U.S. Department
of Transportation
**Federal Highway
Administration**

March 6, 1998

In your February 17 letter to Mr. Henry Rentz, you requested Federal Highway Administration's acceptance of the California Department of Transportation Type 70 Bridge Rail at the National Cooperative Highway Research Program (NCHRP) Report 350 test level 4 (TL-4). To support this request, you sent us a copy of your report: "Vehicle Crash Tests of the Type 70 Bridge Rail," dated January 1998, and a copy of a video tape documenting the certification tests that were conducted.

BRIDGE BARRIER TESTS A & B TYPE 732 CONCRETE BARRIER DETAILS

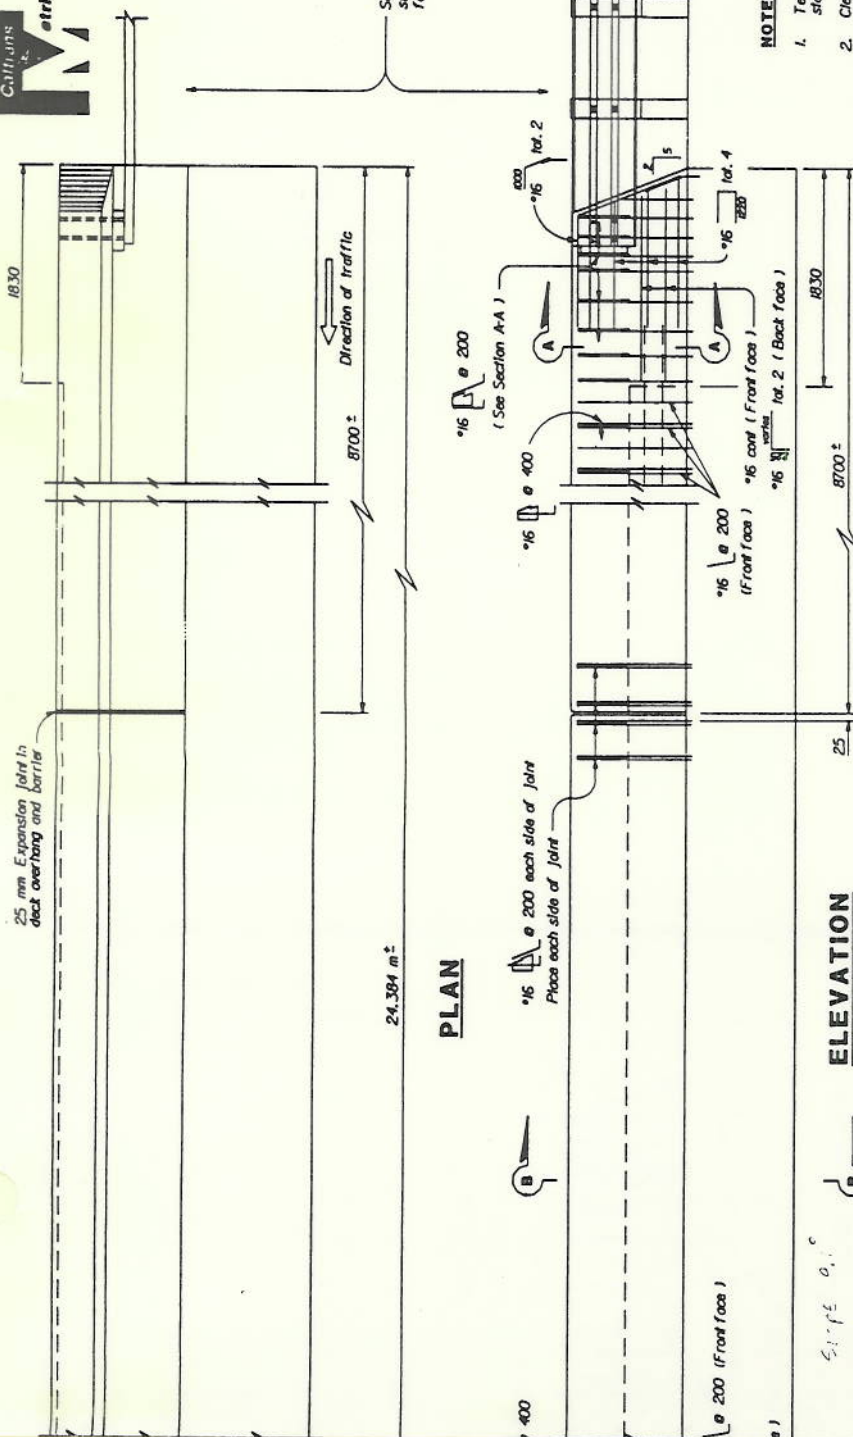
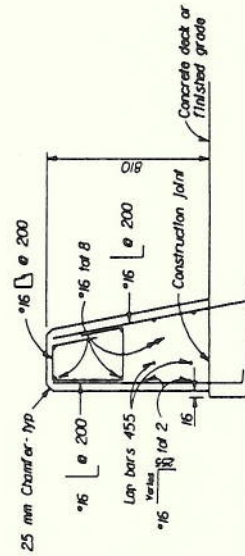
Our review of this material indicated that the Type 70 Bridge Rail is an 810-mm tall concrete barrier with its traffic face sloped at a constant 9.1 degrees away from traffic. This face geometry is identical to your Type 60 roadside/median barrier that was accepted for use on the National Highway System (NHS) at TL-3 in my February 4 letter to you. However, the Type 70 Bridge Rail has a vertical back face with some architectural treatment and is more heavily reinforced than the Type 60. Design details are shown in Enclosure 1.

Figure 2.22 - Test 512 Data Summary Sheet

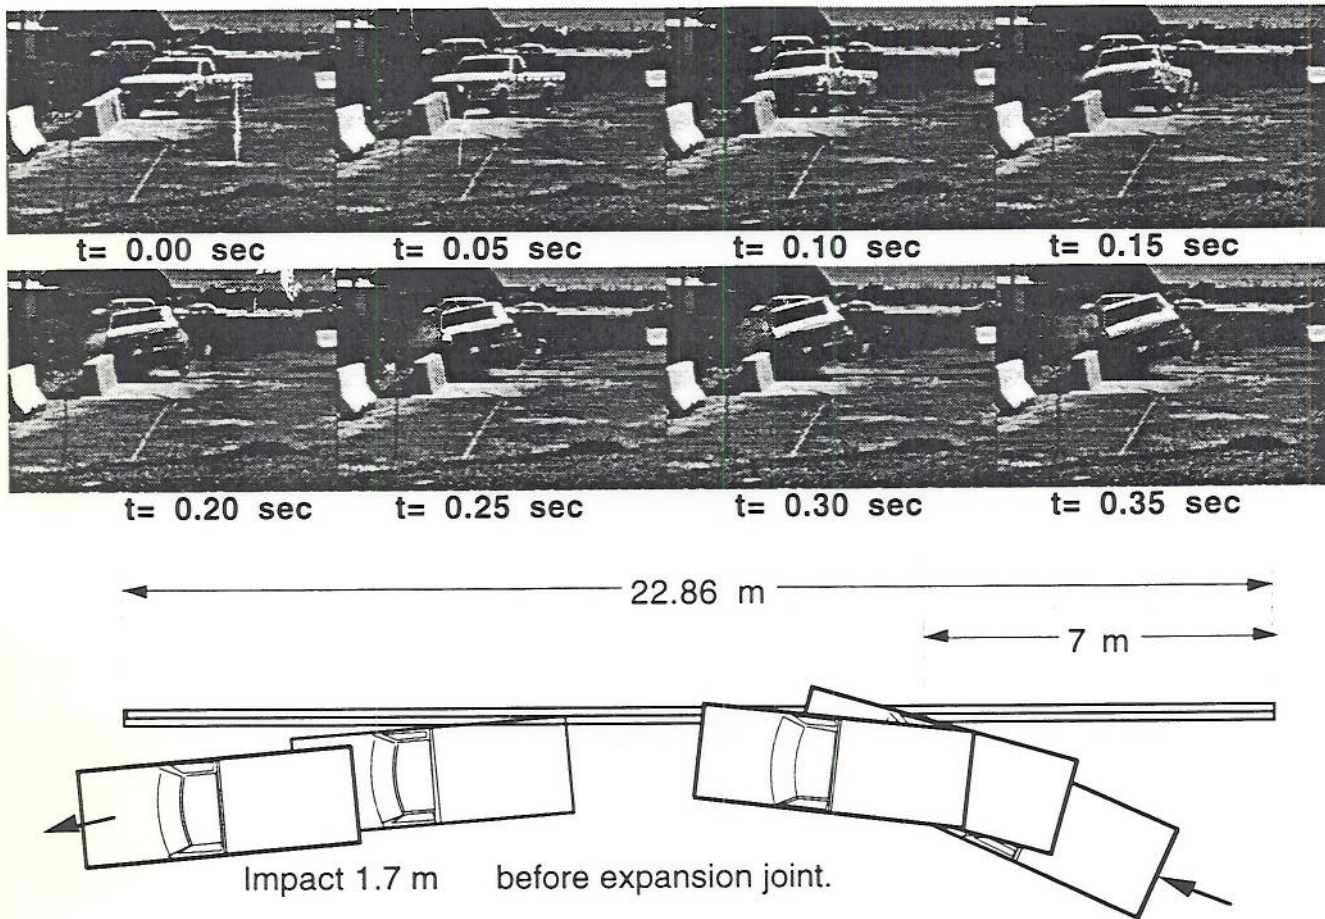
We noted that three tests were reported, including test 4-12 with an 8000 kg single-unit truck impacting the barrier at an angle of 15 degrees and a speed of 80 km/h. Each of these tests met appropriate NCHRP Report 350 evaluation criteria. The individual test results are summarized in Enclosure 2. We noted also that test 4-11 was re-run after a first unsuccessful attempt in which the pickup truck rolled over after impact. You theorized that the non-standard floating rear hub of the test vehicle caused the drive shaft to pull out of the transmission housing on impact and that the shaft then dug into the test track and precipitated the rollover. This test was then re-run with a pickup truck with a standard wheel hub. Considering the successful retest and the earlier pickup truck tests with your Type 60 constant slope barrier as well as successful pickup tests with the New Jersey, F-profile, and the Texas Department of Transportation constant slope barrier, we are willing to consider test 512 (NCHRP Report 350 test 4-11) as an anomaly.
